PLANNING COMMISSION REGULAR DOCKET TUESDAY, February 14, 2023 at 5:30 P.M. Hybrid Meeting

PLANNING COMMISSION REGULAR MEETING
APPLICATION FOR A CRITICAL SLOPE WAIVER
APPLICATION NUMBER: P22-0132
DATE OF MEETING: February 14, 2023

ERB Staff report prepared by: Jeff Werner, AICP, Preservation and Design Planner

Submittal: Mitchel/Matthews Architects & Planners drawings for *2005 Jefferson Park Avenue Entrance Corridor Review Application*, dated December 20, 2022: Sheets 1 (cover) through 76.

CRITICAL SLOPES EXHIBIT - ZONING & SUBDIVISION ORDINANCE

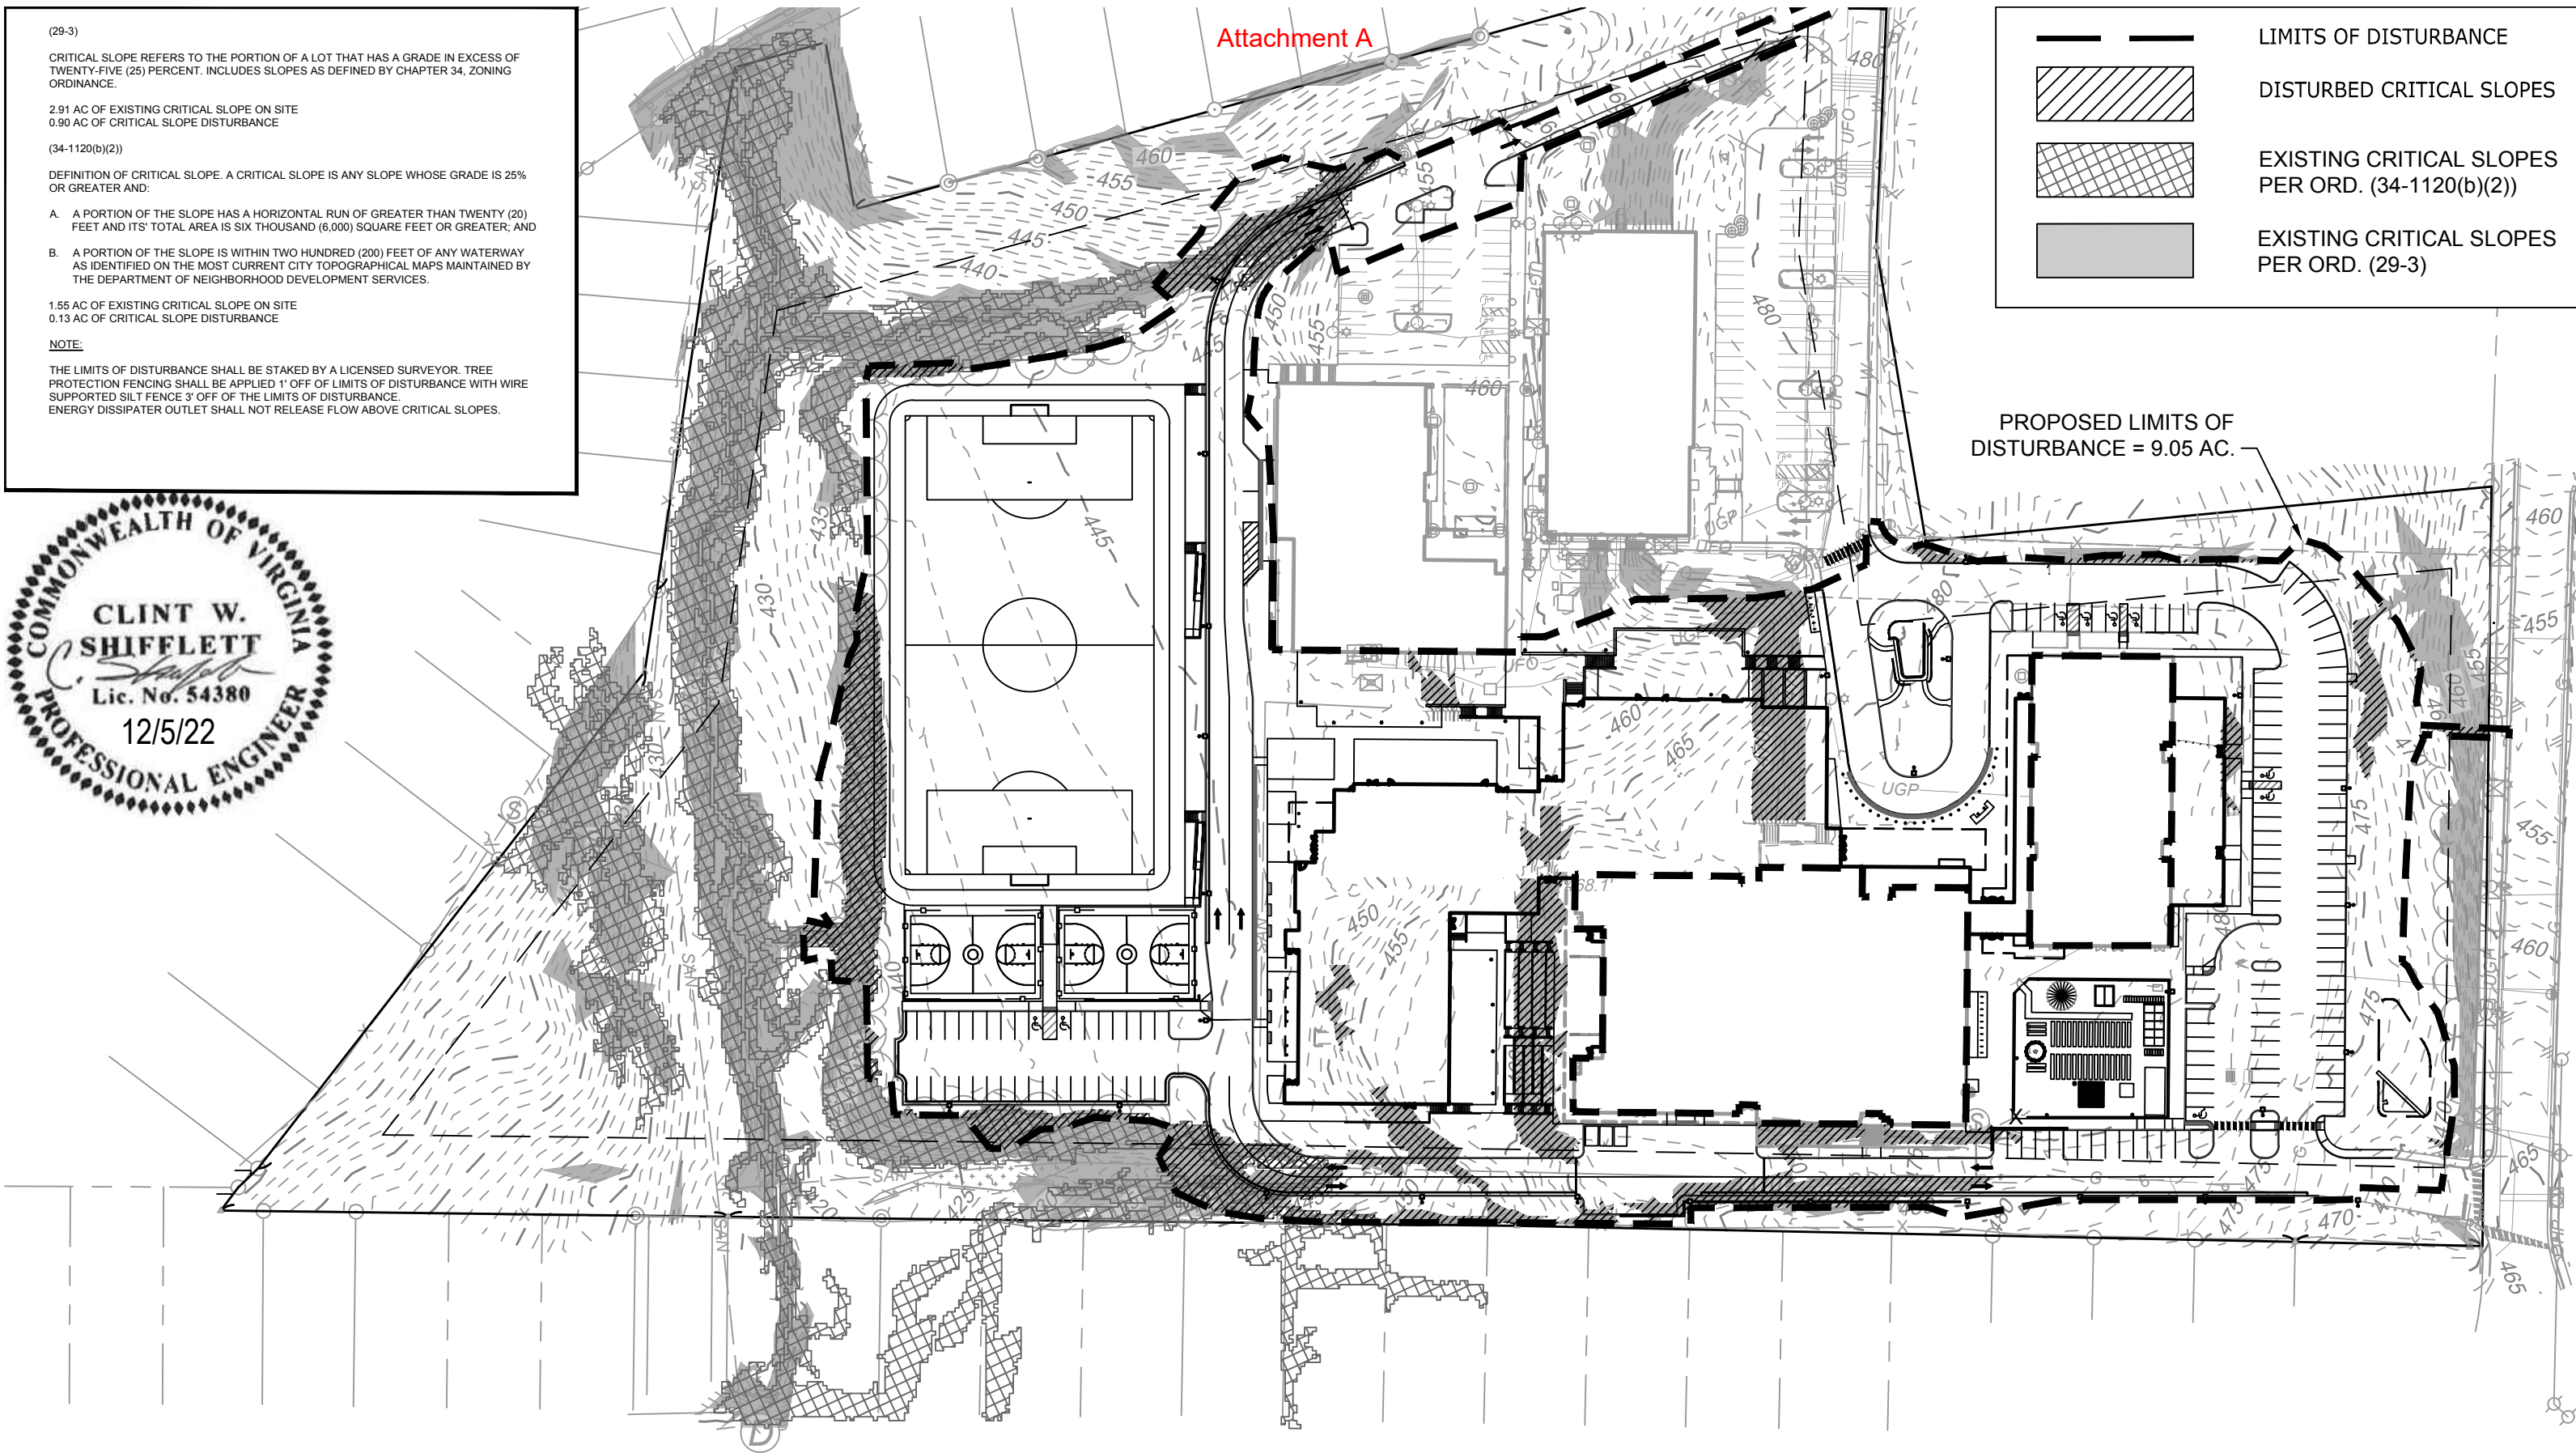
Staff believes the existing Critical Slope are manmade and the product of grading for the existing athletic field. The proposed renovations and reconfiguration of the site calls for keeping the athletic field in the same location, but enlarging it to provide more activities, allow room for the new bus route, and facilitate ADA circulation. Staff supports Finding#2 under unusual topography as it relates to manmade slopes.

1. The applicant will work with the City's Urban Forester on tree preservation and replanting.
